**URGENT FIELD SAFETY NOTICE
MEDICAL DEVICE CORRECTION**

**FSCAs 2249723-06/02/2023-010-C, 2249723-06/02/2023-011-C,
2249723-06/02/2023-013-C & 2249723-06/02/2023-014-C**

Datascope Cardiosave Hybrid and Rescue Intra-Aortic Balloon Pumps (IABP)

Figure 2-5: Grasping the Fiber-Optic sensor connector

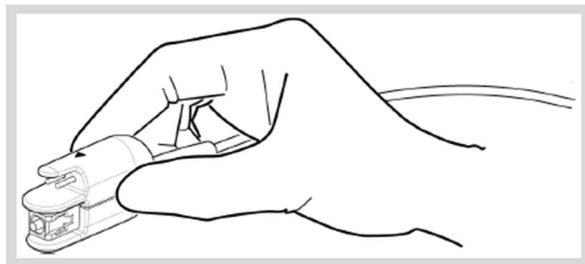
The Fiber Optic connector is designed to fit smoothly into the IAB Sensor Input. The red triangle on the top of the connector should align with the red triangle on the Cardiosave console. Inserting the Fiber Optic connector into the port without verifying the correct alignment can lead to internal damage. If difficulty is encountered when inserting the connector, verify that the connector is in the correct position and attempt to reinsert into the IAB Sensor Input.

Excessive force can cause damage to the connector and the internal fiber optic assembly of the IABP console. This may cause a disruption in the fiber optic signal acquisition resulting in an inability to acquire a fiber optic signal on the Cardiosave IABP. Following proper insertion procedures will minimize the potential for damage to the connector and a loss of signal. This conclusion is based on field observations seen through the complaints evaluation. As part of Datascope's investigation testing will be performed to confirm this observation.

In step 4, when the Fiber-Optic connector is inserted into the IAB Sensor input until an audible "click" is confirmed, ensure that you are not using excessive force as that can lead to damage to the Cardiosave.

1. With one hand, grasp the Fiber-Optic Sensor Connector as shown in Grasping the Fiber-Optic sensor connector, with the red triangle visible on top.

2. Remove and discard the protective cover from the Fiber-Optic IAB connector. Do not touch the exposed end of the Fiber-Optic cable.
3. With the other hand, open the protective shutter that covers the opening for the IAB Sensor Input (item 11, section 1.5.1) by rotating it to the left.
4. Insert the Fiber-Optic IAB connector into the IAB Sensor Input until it "clicks".

Ensure that the red triangles on the Fiber-Optic IAB Sensor Connector and on the back panel are in alignment.
